# Access Compliance Report

## Public Rights-of-Way

### (Curb Ramps)

Intersection ID: N/A	Main Street: 3RD_ST	Cross Street: JOHN_BELK_PY	Location: NW
ADA ID: CF0957E04806	Ramp Type: Perp	Initial Pass/Fail: Fail	Overall Compliance: No
Severity Score: 12.5			
Codes/Mitigation Info/Possible Solution		Field Measurements/Component Compliance

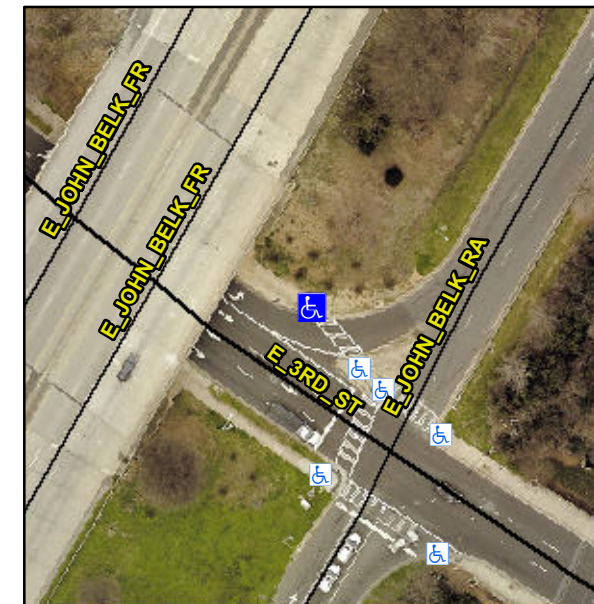
**Not Found, R304.2.2**

Compliance	Description	Data	Compliance	Description	Data
N/A	Ramp Length (in)	64.0	No	Ramp Slope (%)	10.2
Yes	Ramp Width (in)	48.0	Yes	Ramp XSlope (%)	0.8
N/A	Flare Type LT	N/A	N/A	Flare Type RT	N/A
N/A	Flare Slope LT (%)	N/A	N/A	Flare Slope RT (%)	N/A
N/A	Flare Traversable LT?	N/A	N/A	Flare Traversable RT?	N/A
N/A	Landing Length (in)	N/A	N/A	DWS Provided?	N/A
N/A	Landing Width (in)	N/A	N/A	DWS Contrast?	N/A
N/A	Landing Slope (%)	N/A	N/A	DWS Length (in)	N/A
N/A	Landing X Slope (%)	N/A	N/A	DWS Full Width?	N/A
N/A	Landing Curb? (Y/N)	N/A	N/A	DWS Offset (in)	N/A
N/A	Shared Landing?	N/A			
N/A	Gutter Ponding?	N/A	N/A	Gutter Slope (%)	N/A
N/A	Gutter Lip Ht (in)	N/A	N/A	Gutter X Slope (%)	N/A
N/A	Painted X Walk1?	Yes	N/A	Painted X Walk2?	N/A
	X Walk 1 Direction	To SE		X Walk 2 Direction	N/A
N/A	X Walk 1 Width (in)	107.0	N/A	X Walk 2 Width (in)	N/A
	X Walk 1 Slope (%)	2.9		X Walk 2 Slope (%)	N/A
	X Walk 1 X Slope (%)	2.8		X Walk 2 X Slope (%)	N/A

**Remove & Replace Entire Ramp.**
